**INSPECTION DATE: 11/14/2023**

**REPORT DATE: 11/27/2023**

MEETING DATE: 12/14/2023

**VARIANCE REQUEST:** The applicant is requesting relief from St. Louis County Zoning Ordinance 62, Article IV, Section 4.3 D, to allow an addition to a principal dwelling located between the shore impact zone and required setback to exceed 400 square feet allowed and to exceed the maximum height allowed of 25 feet.

Applicant Site Sketch

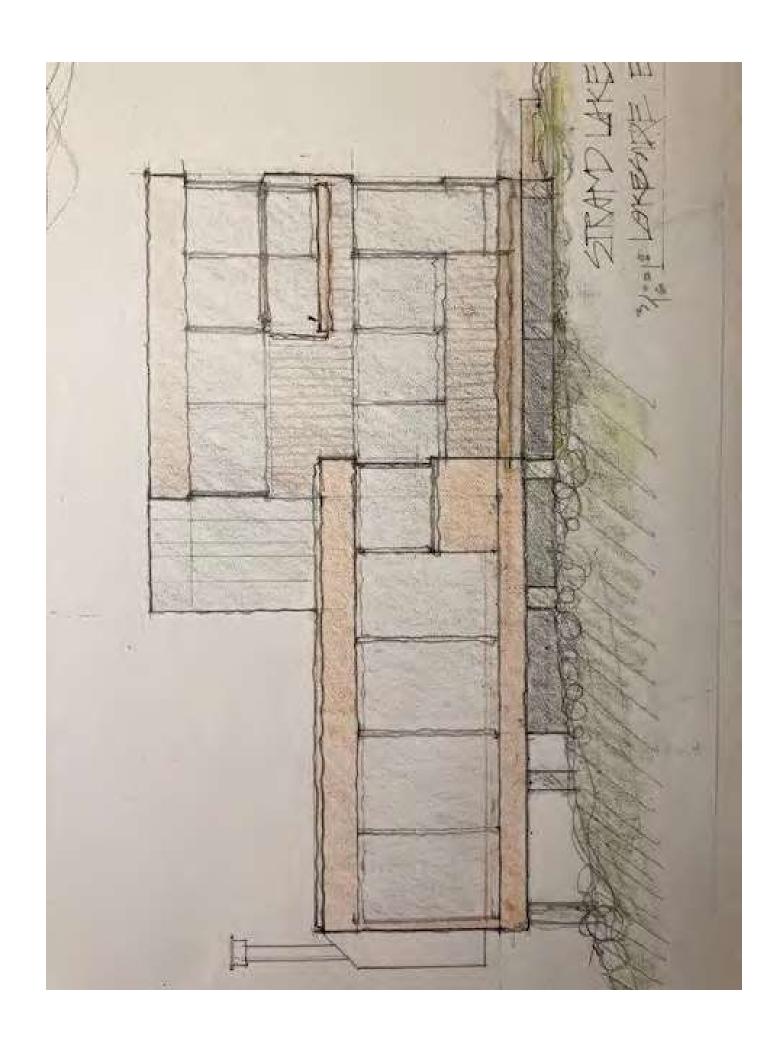
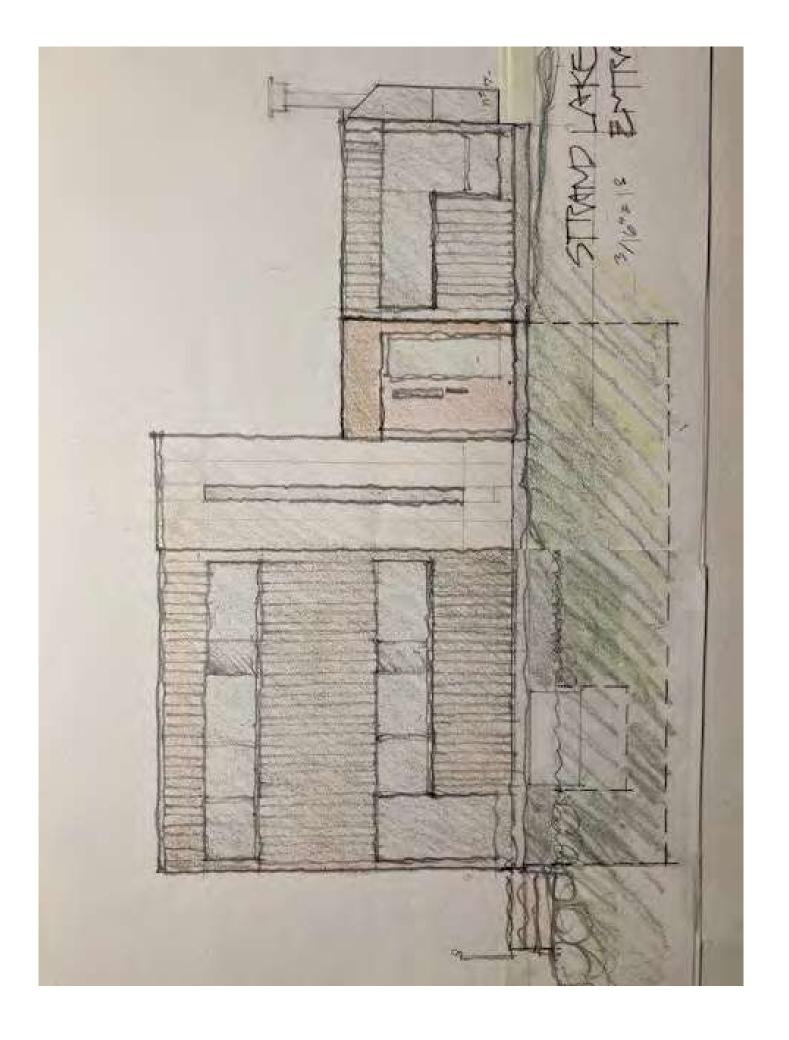
Your red lines circling the added space were correct. I recalculate the square footage in the following way.

There will be a basement under the addition to the entry side (SE) of the building. The basement will be under the entry, stairway, hallway, bathroom, and bedroom. The basement was not drawn on the elevations I sent you. I will send new elevations.

The height of the planned building (with addition) will be 23 feet. The height from the ground to the bottom of the original building at the NE corner is 3 feet 5 inches. Total height will be about 26.5 feet.

The new sketch of the basement has an egress window well (for safety) on the SE side.
